Planning Approval Consistency Assessment Form

Assessment name:	Station Precinct design updates
Prepared by:	Sydney Metro
Prepared for:	Sydney Metro, Downer & HSEJV
Assessment number:	TfNSW51
Status:	Final
Version:	1.0
Planning approval:	SSI 8256
Date required:	November 2021
iCentral number:	SM-21-00198074
© Sydney Metro 2020

Appendix A – SWM Station upgrades design elements

A2 – Hurlstone Park Station

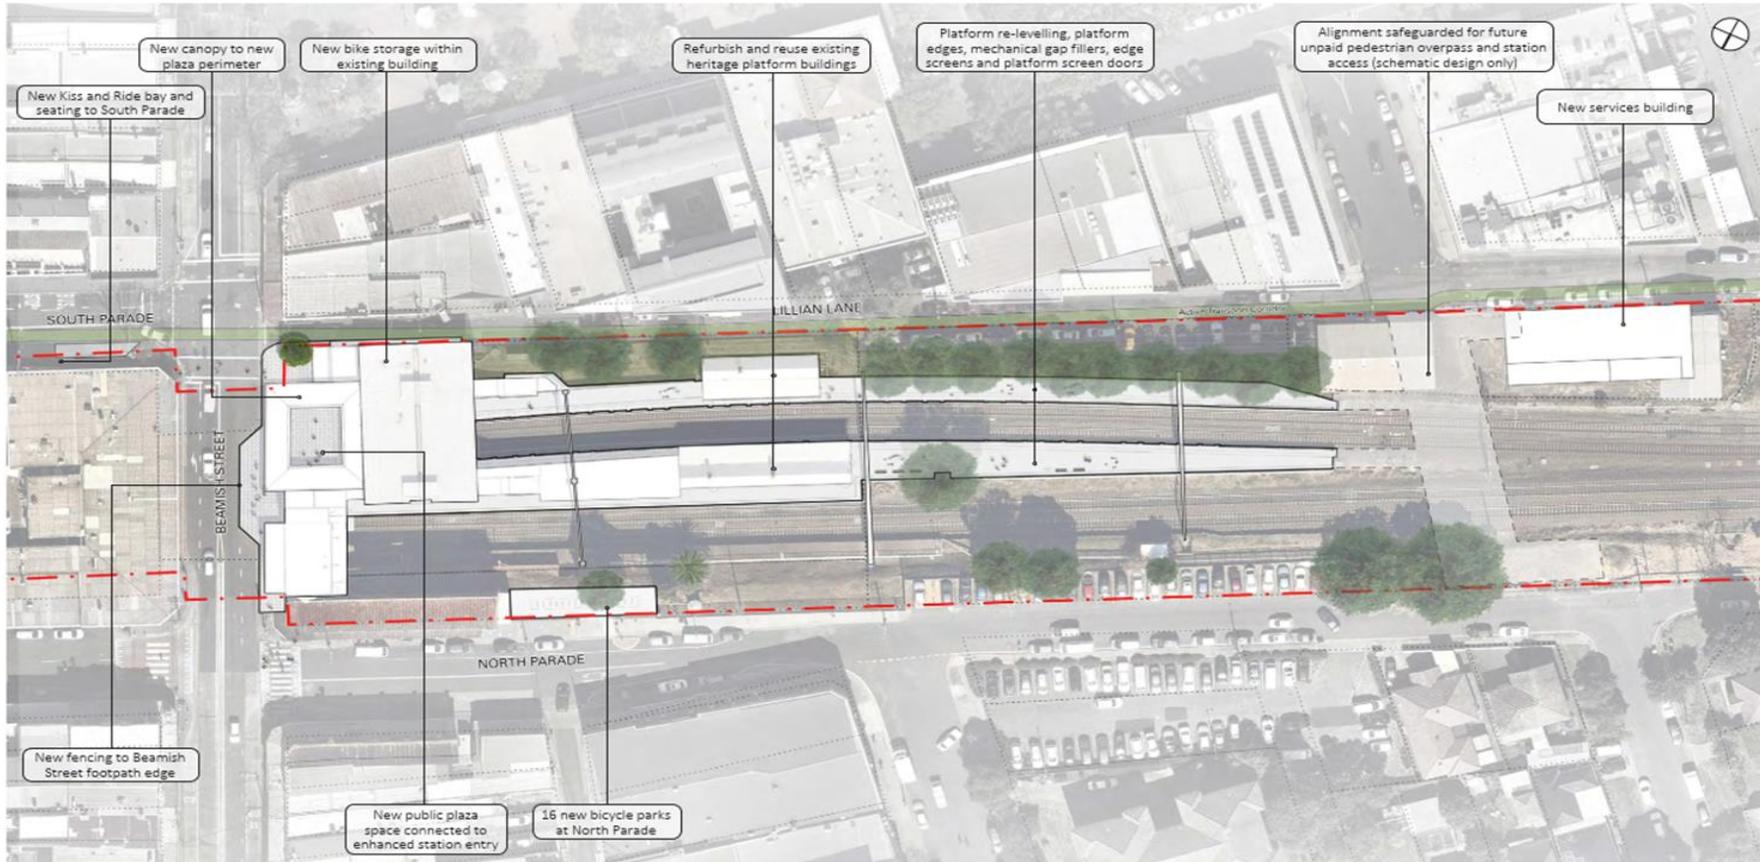
- Relocate the proposed taxi parking to the southern side of Floss Street across from Station entrance

Indicative location of proposed relocated taxi parking
